ADDENDUM NO.1

Date: **June 28, 2021**

Subject: **Addendum No.1 to Contract Documents
City of Mercer Island
Booster Chlorination System Project (Bid #21-28)**

VERIFY SCALES	JOB NO. 11540C.10
BAR IS ONE INCH ON ORIGINAL DRAWING	DRAWING NO. E02
IF NOT ONE INCH ON THIS SHEET, ADJUST SCALES ACCORDINGLY	SHEET NO. 27 OF 55

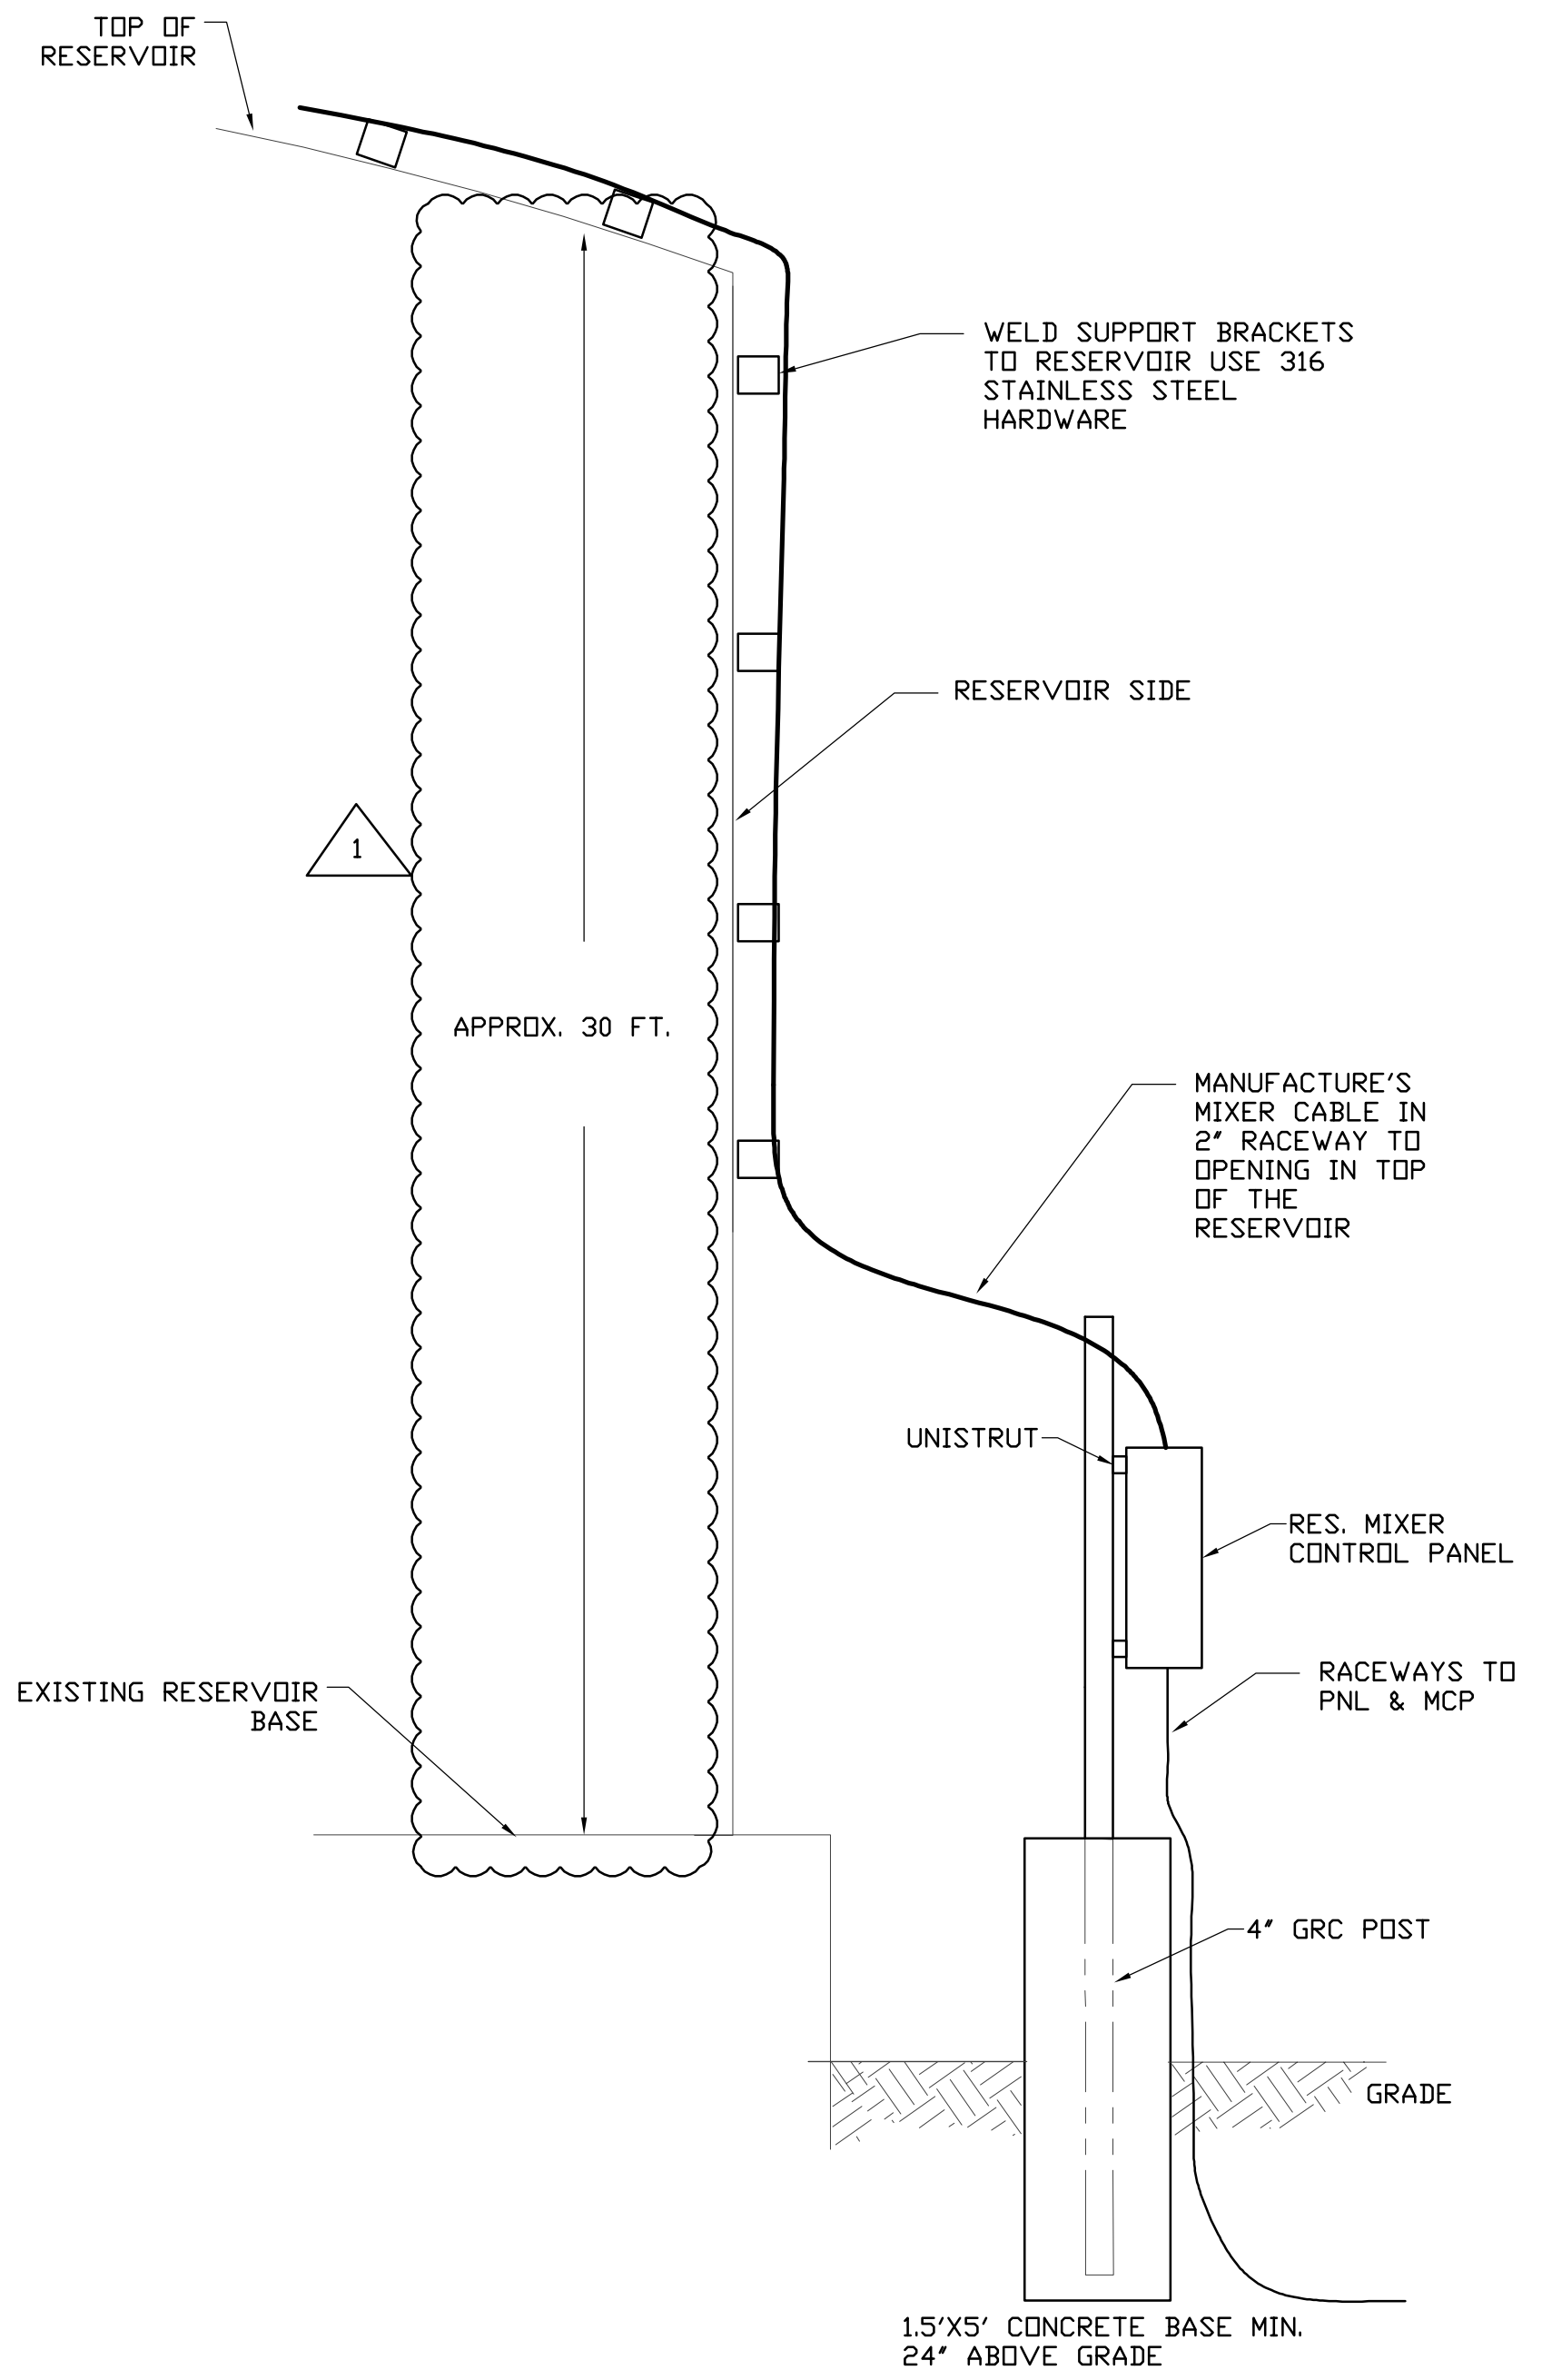
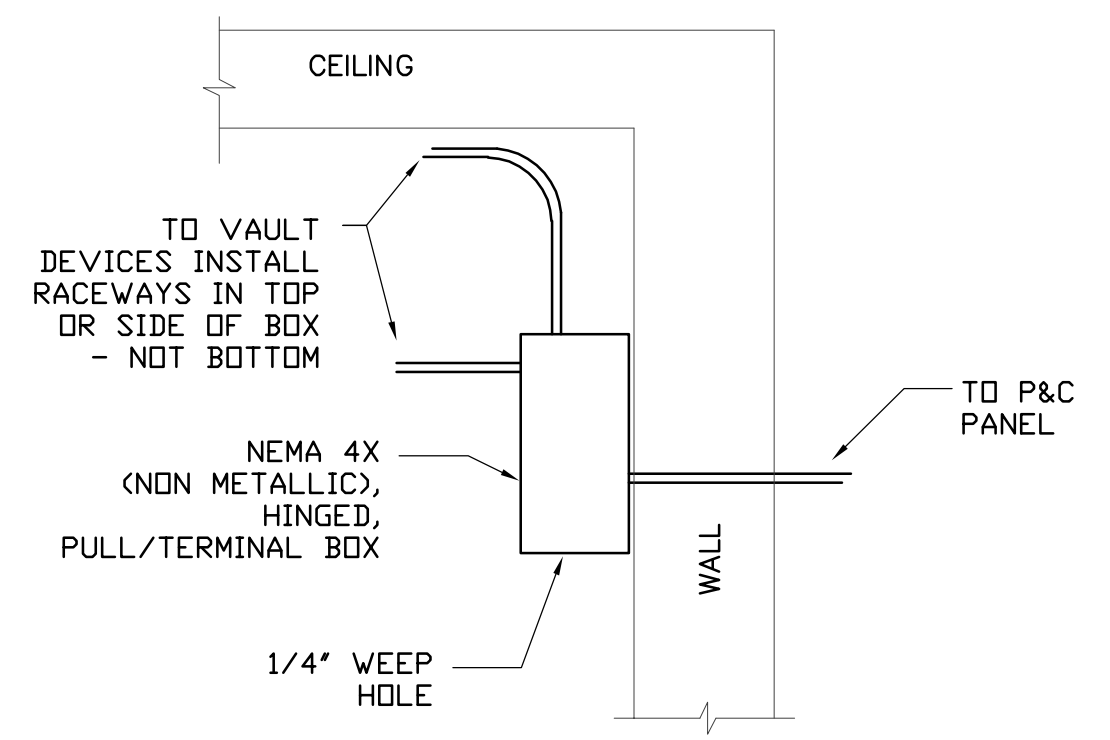
- 14) Per drawing E02, conduit needs to be run to the top of the reservoir tanks. Please let us know what the height of the tanks are?

- 16) Where are the flow meter vault and the water isolation pull box located that are shown on drawing E02? We don’t see them on the floor plan

Response: The height of the tanks are: 32’ for the North Reservoir and 32’-6” for the South Reservoir

Response: This detail is for the flow meter vault at the SE 40th St. PRV site, see Drawings E13 and E14.

VERIFY SCALES	JOB NO. 11540C.10
BAR IS ONE INCH ON ORIGINAL DRAWING	DRAWING NO. E04
IF NOT ONE INCH ON THIS SHEET, ADJUST SCALES ACCORDINGLY	SHEET NO. 29 OF 55

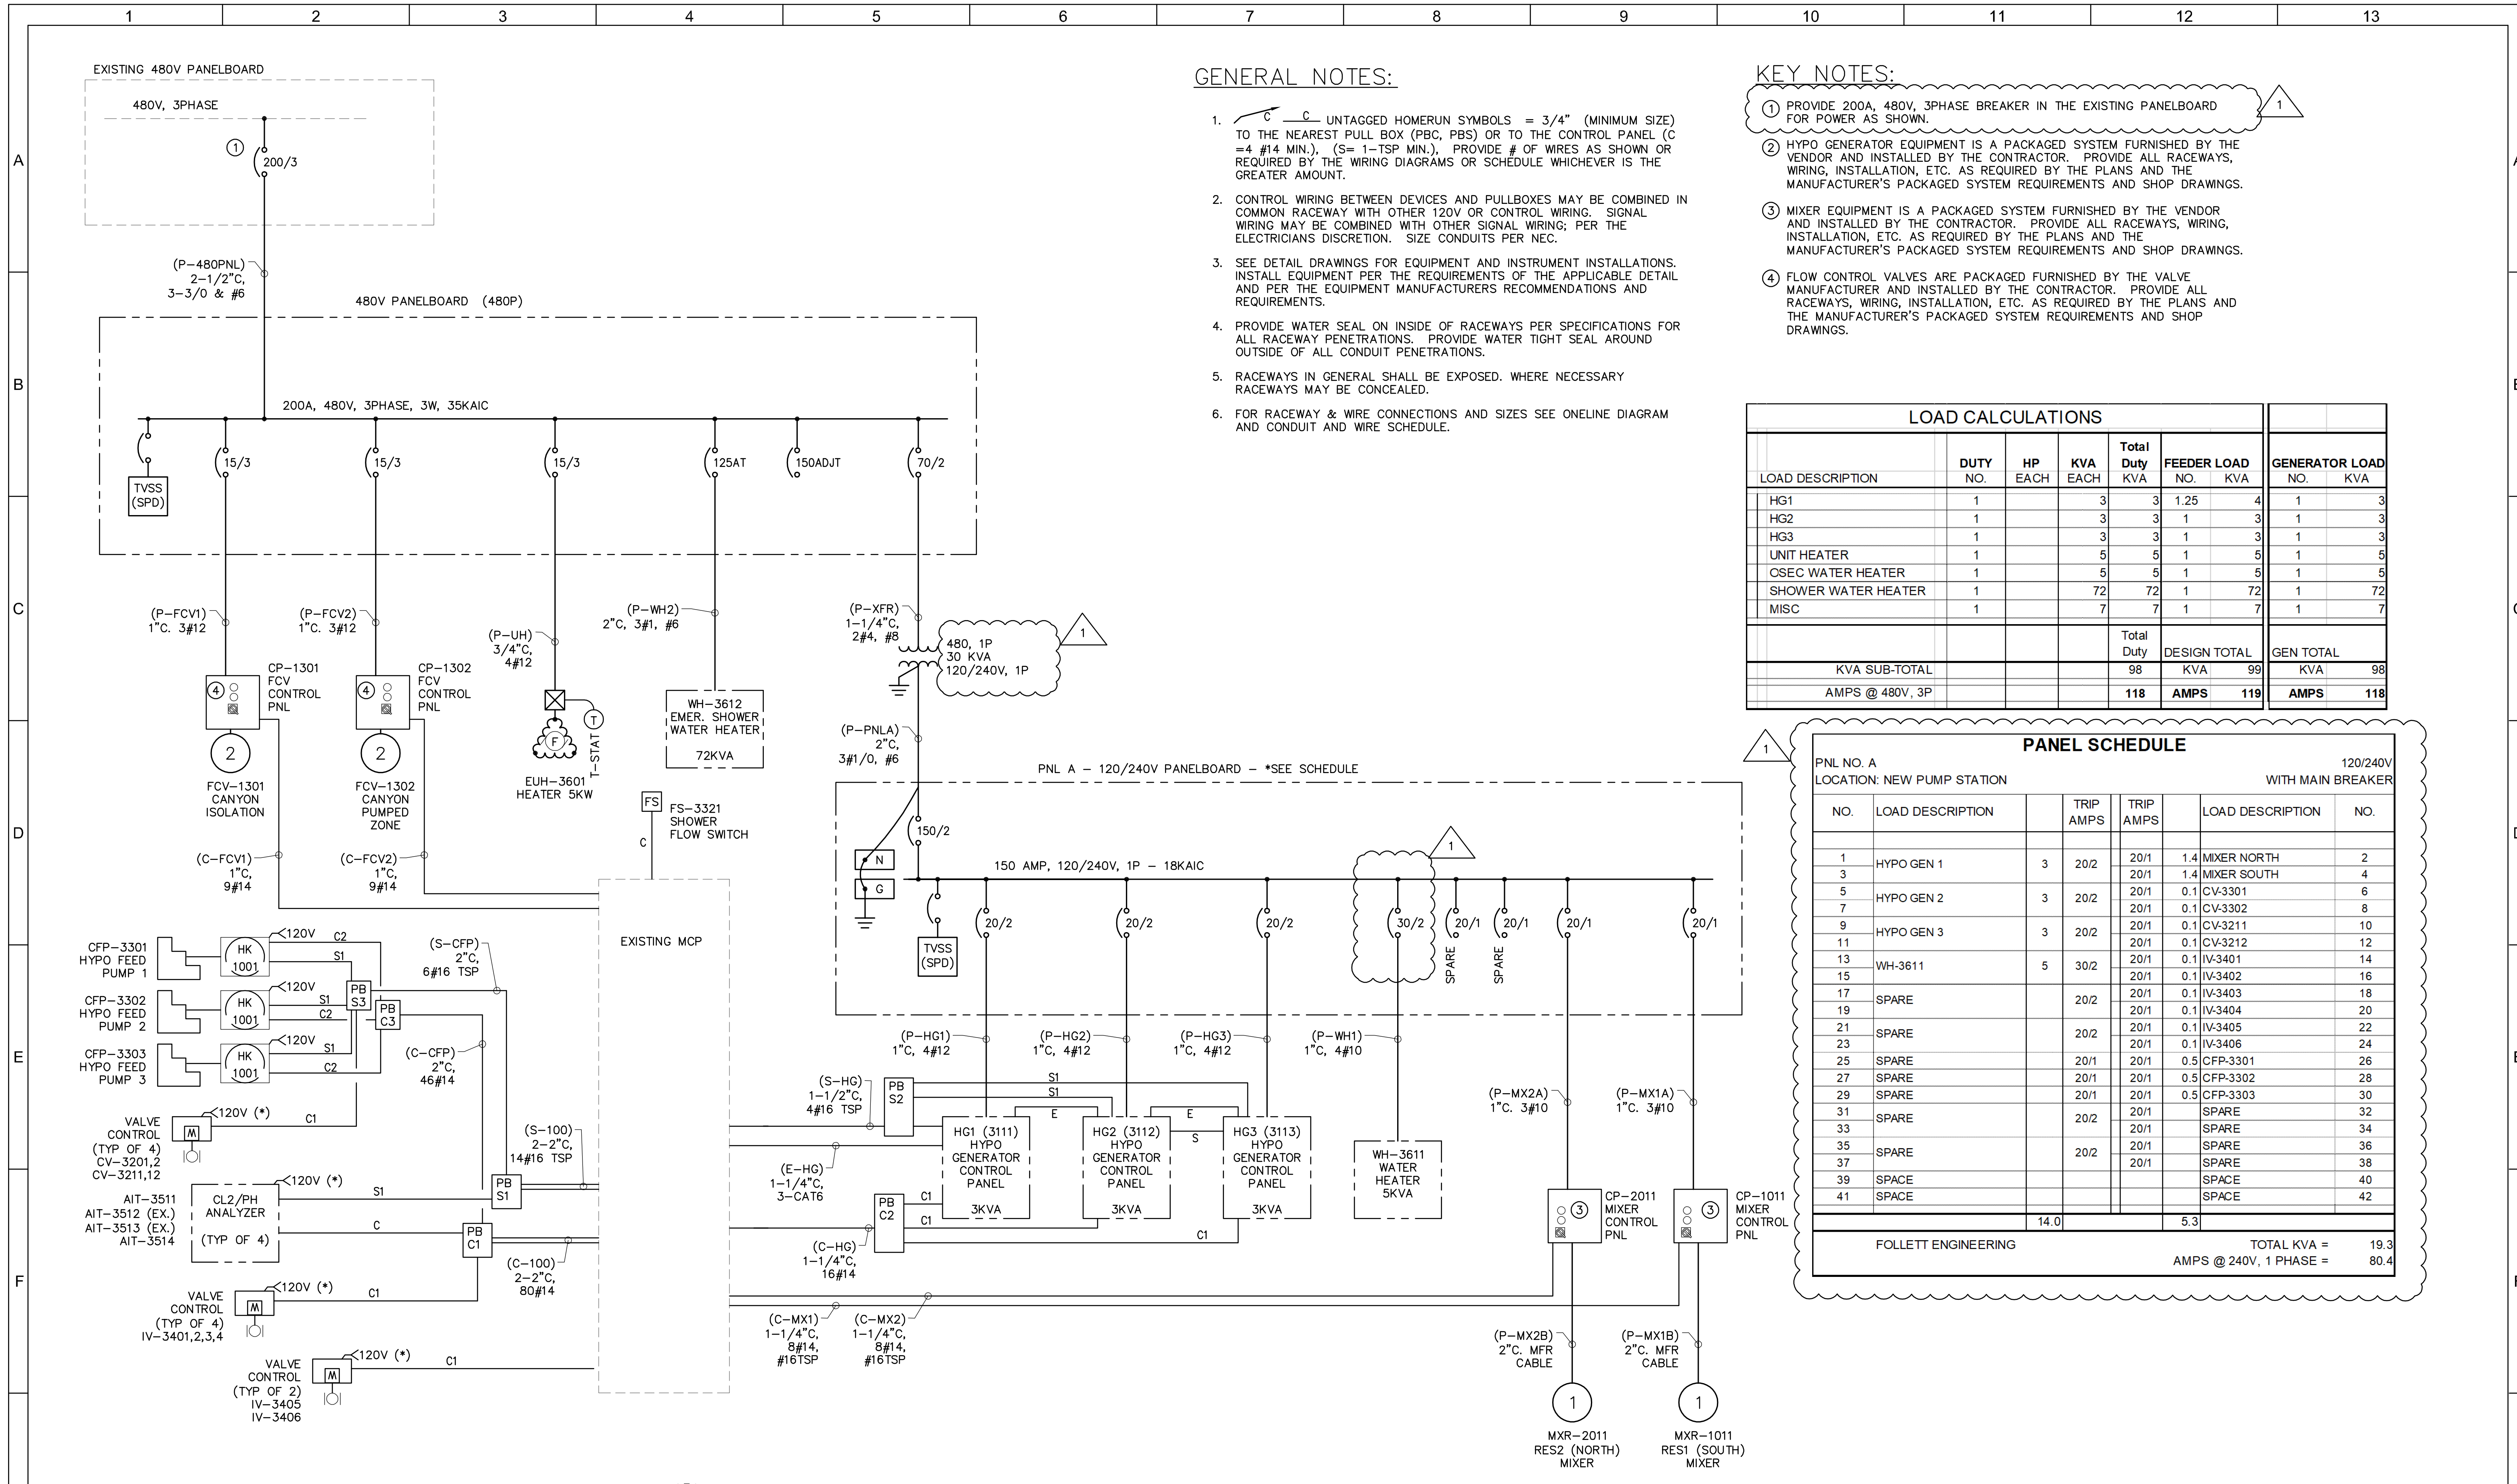
- 15) On drawing E04, EUH-3601 Heater and thermostat are shown on the one line. Please indicate where on the drawings this is located? We don’t see it on the floor plan anywhere

- CFP-3301 Hypochlorite Pump 1
- CFP-3302 Hypochlorite Pump 2
- CFP-3303 Hypochlorite Pump 3

Response: EUH-3601 heater will be located on the north wall in the Sodium Hypochlorite Room with the thermostat on the south wall as shown below. This update will be included in a future addendum (see Addendum 1).

Response: The Hypochlorite Pumps are powered (120 V) – this is shown on the online diagram Drawing E04.
